Road Safety Assessment Report

D-3 State Route 16, from I-505 to County Road 78 near Brooks

03-Yol-16-PM 18.6/31.7

April 2012

AREA OF CONCENTRATED FLOODING

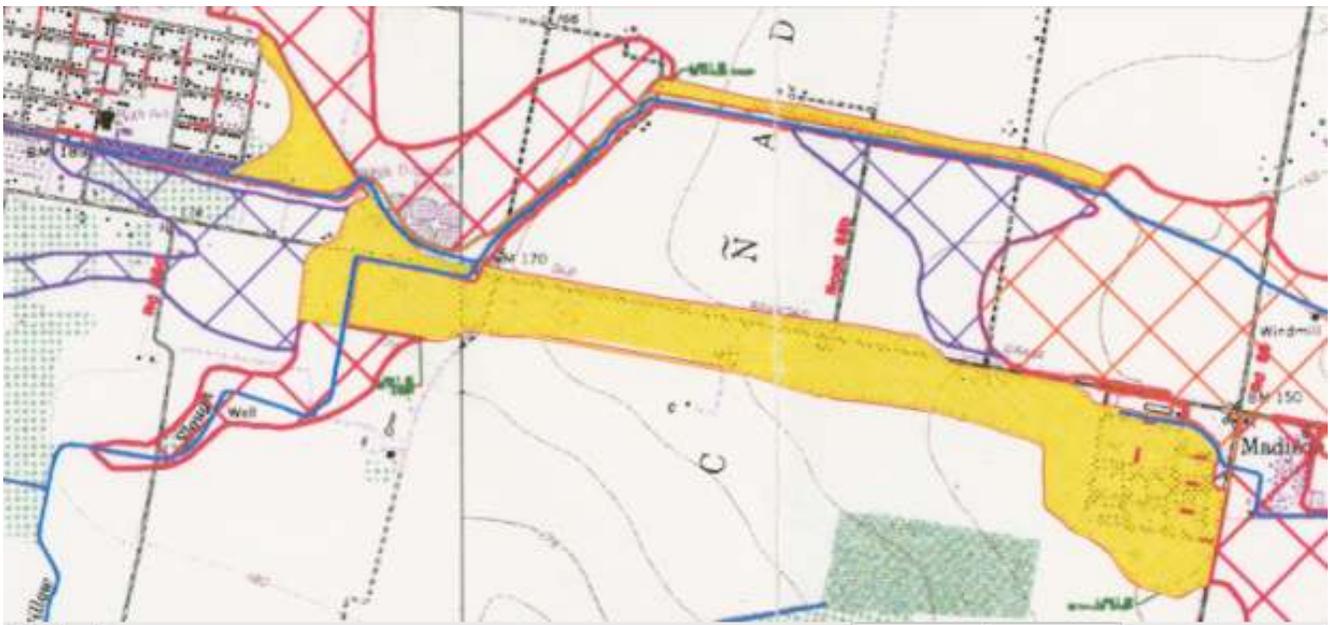
The RSA team understood that the flooding is concentrated between where the South Fork Willow Slough first crosses SR 16 and the City of Madison (depicted below by the yellow shaded area).

SR 16 is closed by the California Highway Patrol (CHP) under flooding conditions between Madison and Esparto – typically between the CR 89 intersection and Willow Slough. The towns that flood in the valley upstream of Esparto typically share information with downstream towns when the flood stages have arrived, and therefore the Esparto and Madison authorities have the ability to mobilize and prepare for the impending flood, including barricading the portion of SR 16 at CR 89 and at CR 21A. There have been isolated cases of motorists bypassing the barricades. If SR 16 is inundated, the flooding many times affects I-505 as well. Any proposed flood protection improvements proposed for SR 16 must also consider the effects on I-505, as it is the principle access route for emergency responders.

At this time, there are no changeable message signs (CMS) and other Intelligent Transportation Systems (ITS) elements to inform roadway users of flooding conditions and detours. Caltrans could deploy ITS to detect and inform motorists of flooding conditions and detours by positioning CMS at key locations. An emergency readiness/ continuity of operations plan can be prepared by Caltrans, Yolo County, California Highway Patrol, and the Tribe to determine the key locations for the CMS equipment and appropriate messaging. The ITS and CMS equipment will improve local operations, and they can be used for purposes other than flooding, such as the accommodation of special events. This is a low-cost, high-impact countermeasure which provides a very cost-effective alternative to Caltrans' previous proposal to construct a new, raised SR 16 in this corridor.

POSSIBLE DETOUR OF FLOODED AREA

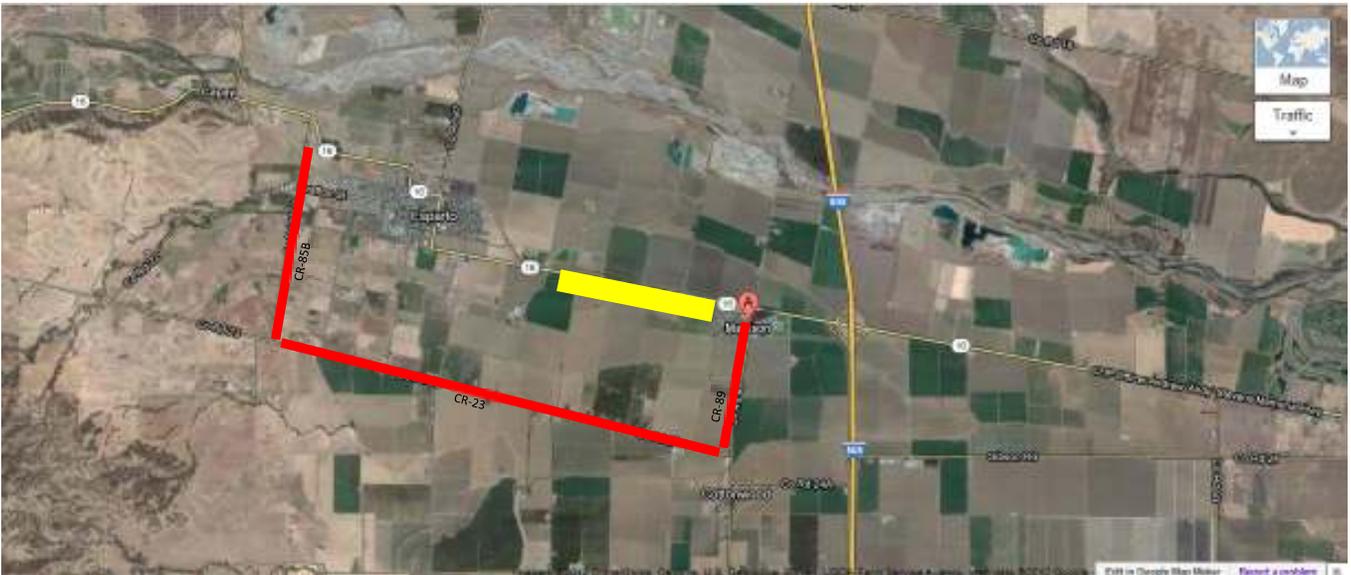
The area blocked by flooding on SR 16 shown above can be bypassed via a detour of CR 89 to CR 23 to CR 85B as shown in the image to follow, titled “Possible Detour of Flooded Area.” Although the roads that comprise this detour route also experience flooding, the flood depth and duration tend to be less than SR 16.

DIAGRAM SHOWING 8-FOOT SHOULDER AS THE FIRST PART OF THE 20-FOOT CRZ

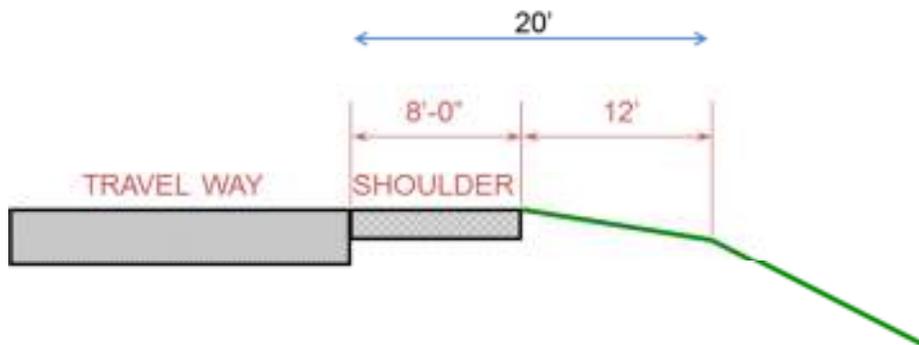
This countermeasure would incorporate a 20-foot CRZ. The roadway cross section would consist of 12-foot travel lanes, an 8-foot paved shoulder, and an additional 12 feet of clear slope, built mostly on existing alignment. (Some minor offsets may be needed to flatten a horizontal curve, for example.) This total 32-foot cross section can be built almost entirely within the existing 30-foot right of way.

SW-2 Provide full standard-width cross section on same alignment (12-foot lanes, 8-foot shoulders, and 20-foot CRZ with recoverable slopes)

TABER'S CURVE

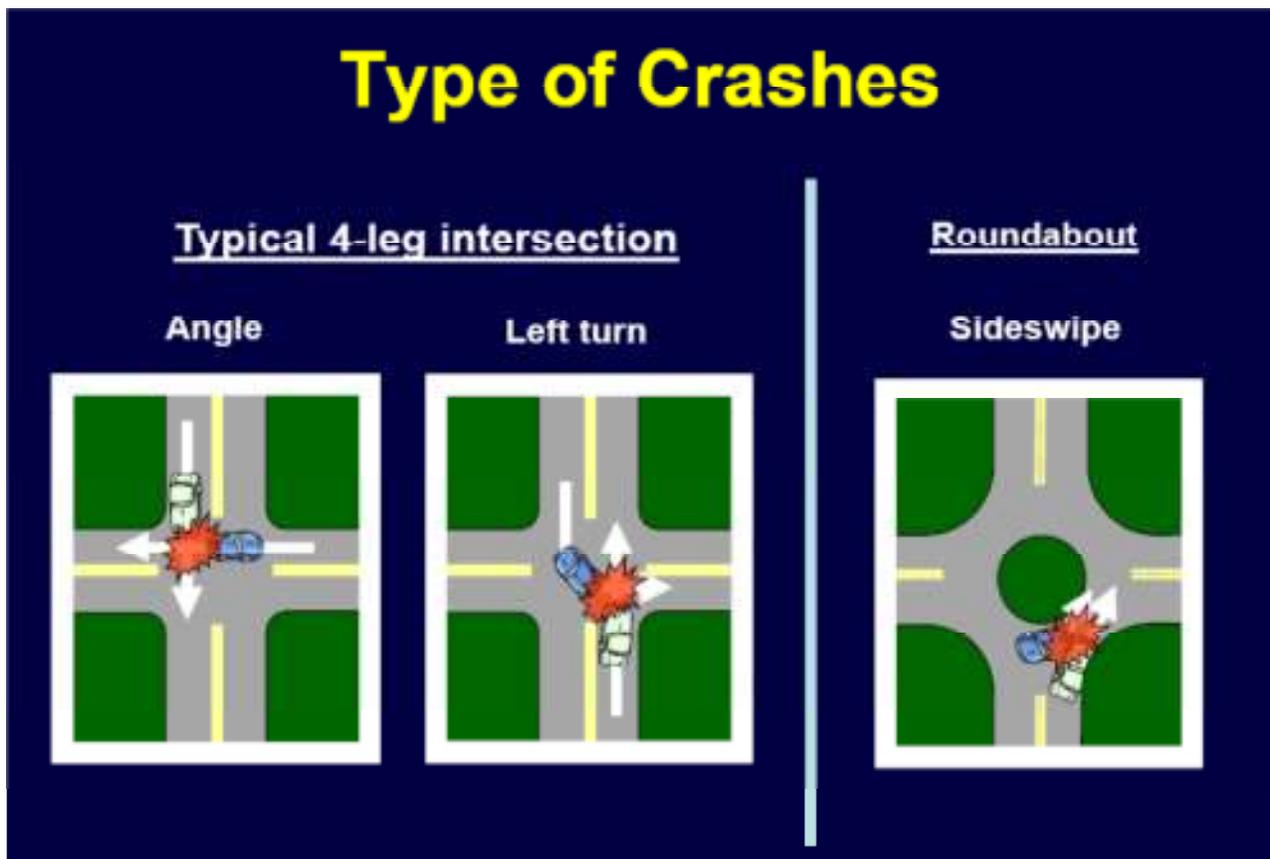
It is common practice to use delineators along the outside edge of roadway curves. The use of these delineators should be standardized throughout the project limits for consistency and clarity of warning to the drivers.

LOOKING EAST FROM THE INTERSECTION OF CR 85B AT SR 16

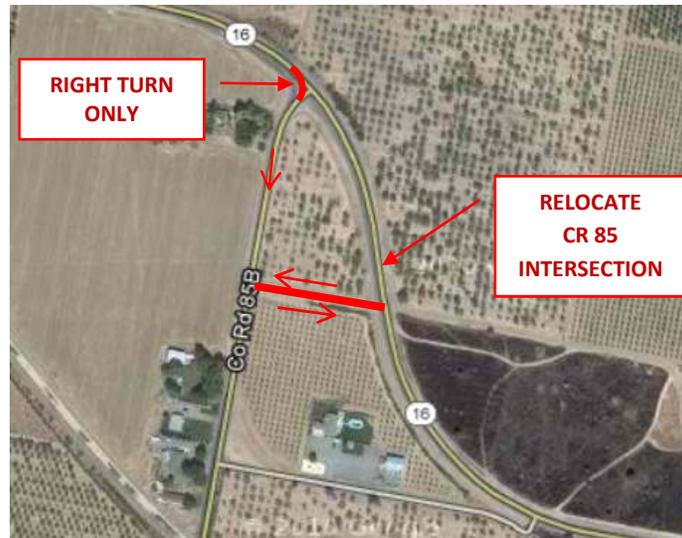
The one-way stop at CR 85B has limited intersection sight distance that compromises left turns from CR 85B to westbound SR 16. There are a few trees, possibly as few as three or four that if removed would increase the sight distance available for the previously mentioned movement.

I-9 Remove or trim trees at CR 85B intersection with SR 16

CROSSWALK IN ESPARTO NEAR THE HIGH SCHOOL

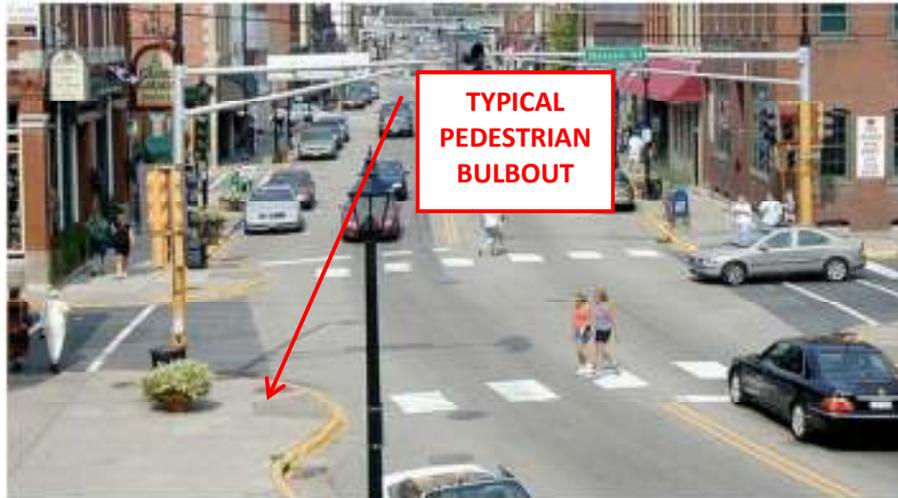
The provision of high-visibility pavement markings (see figure below) following the pedestrian crosswalks would provide greater contrast and draw motorist attention to the presence of the crosswalk. This would be particularly beneficial for nighttime conditions.

PS-1 Install high-visibility pavement markings for pedestrian crosswalks
